Access Compliance Report

Public Rights-of-Way

(Curb Ramps)

Intersection ID: 10013612	Main Street: BARRYMORE_DR	Cross Street: N/A	Location: W
ADA ID: 0B7368ABFC78	Ramp Type: Perp	Initial Pass/Fail: Fail	Overall Compliance: No
		Severity Score: 12.5

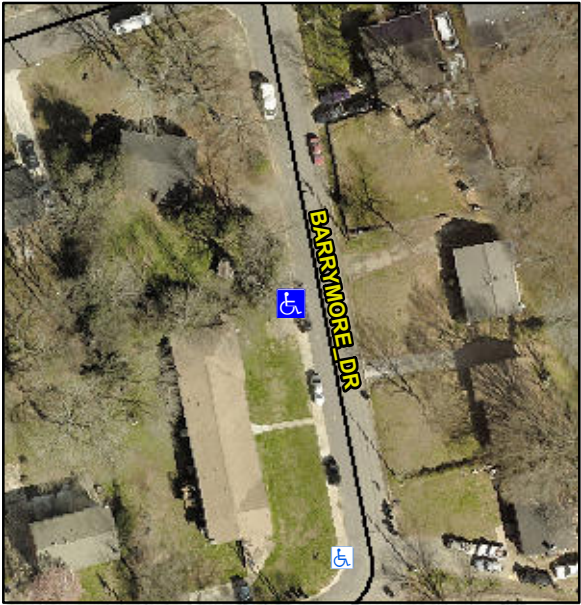
Codes/Mitigation Info/Possible Solution			Field Measurements/Component Compliance		
	Possible Solutions:		Compliance	Description	Data
	Remove & Replace Entire Ramp.		Yes	Ramp Length (in)	47.0
			No	Ramp Width (in)	48.0
			N/A	Flare Type LT	N/A
			N/A	Flare Slope LT (%)	N/A
			N/A	Flare Traversable LT?	N/A
			N/A	Landing Length (in)	N/A
			N/A	Landing Width (in)	N/A
			N/A	Landing Slope (%)	N/A
			N/A	Landing X Slope (%)	N/A
			N/A	Landing Curb? (Y/N)	N/A
			N/A	Shared Landing?	N/A
			N/A	Gutter Ponding?	N/A
			N/A	Gutter Lip Ht (in)	N/A
			No	Painted X Walk1?	N/A
			To E	X Walk 1 Direction	N/A
			N/A	X Walk 1 Width (in)	N/A

4.2	X Walk 1 Slope (%)	N/A
			5.0	X Walk 1 X Slope (%)	N/A
			N/A	Ramp inside XWalk1?	N/A
			N/A	Road Slope (%)	N/A
			N/A	Road X Slope (%)	N/A
			N/A	Any Obstructions?	N/A
				Obstruction Type	N/A
			N/A		N/A
			Yes	Surface Condition? (G/P)	Good
Surveyor Notes:					
N/A					
PROW/ADA:					
Not Found, R304.5.3					
Total Cost:					
\$ 1850.00
